Product Change Notification

Issue Date: March 29, 2016

Product Name: AFL3-W15A-BT series

Status: Running change

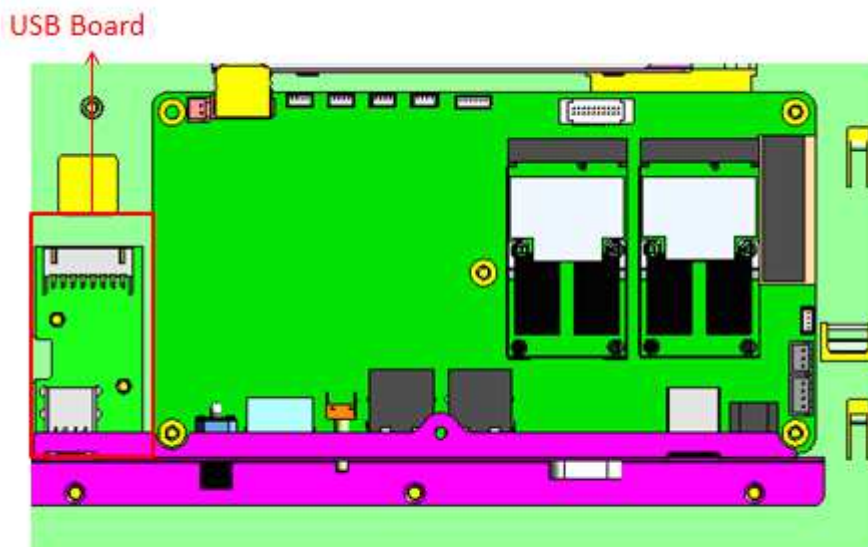
- Phase-out of PCAP touch controller IC

Affected P/N	Replacement P/N
75200-02015607MX-RS (touch controller : EETI EXC7200)	75200-02015608BS-RS (touch controller :EETI EXC3188)

- USB board upgrade to USB hub board

Affected P/N	Replacement P/N
134A048-00-102-RS (Bypass two USB 2.0 to two USB2.0)	134F346-00-100-RS (One USB 2.0 convert to two USB 2.0)

Affected Model	Replacement Model
AFL3-W15A-BT-J1/PC/2G-R10	AFL3-W15A-BT-J1/PC/2G-R11
AFL3-W15A-BT-J1/R/2G-R10	AFL3-W15A-BT-J1/R/2G-R11
